Summary
ELDCA Working Group Meeting
April 12, 2018

St Paul AME Church
Eastwick, PA
6:00 pm - 8:00 pm

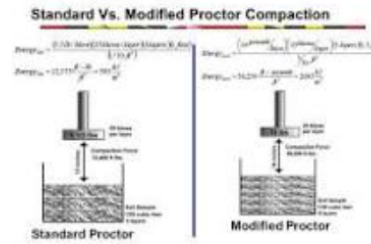
Compaction standard vs modified - (Dr. Starke) (Page 4 of TASC document provided by Skeo)- Dr. Stark is not comfortable with Tetra Tech's decision to use standard Proctor compaction instead of the modified proctor compaction standard. Without greater than 90% standard compaction there is a potentially greater chance that the waste and/or cover will slide or slough to an unknown extent on any portion of the landfill slope. [standard Proctor compaction is what was the norm before modern much heavier earth moving machinery became the norm for earth moving, now modified Proctor compaction is the norm with the use of modern much heavier earth moving machinery that are in use today]. The figure below provides more information.

A soil's optimum moisture content is usually lower when **compacted to modified Proctor versus standard Proctor** specifications. The heavier hammer weight and longer drop distance involved in **modified Proctor** procedures result in more **compaction** energy, creating higher unit weight.

Jason (Tetra Tech – EPA Contractor) shared that 85%-90% of standard Proctor compaction is the industry standard. Goal is not to over harden the soil. Too much compaction will prevent the cover trees from growing.

JC (Tetra Tech) - 85% of standard compaction can be achieved simply by the machinery spreading the soil and driving over the soil. Dr. Stark expressed reservations about TetraTech's choice of using the standard Proctor compaction test and not the modified Proctor compaction test. Dr. Stark asked why TetraTech chose to use that test. Jason's response was that the factor of safety that was attained under standard Proctor testing of the borrow source materials was sufficiently high that any testing under modified Proctor would have a minimal change to the factor safety. And, that factor of safety calculation would still be much higher than the minimum factor of safety required for the cover. While slope is 3 to 1 or less in most places, Dr Stark thinks a little bit more compression is needed.
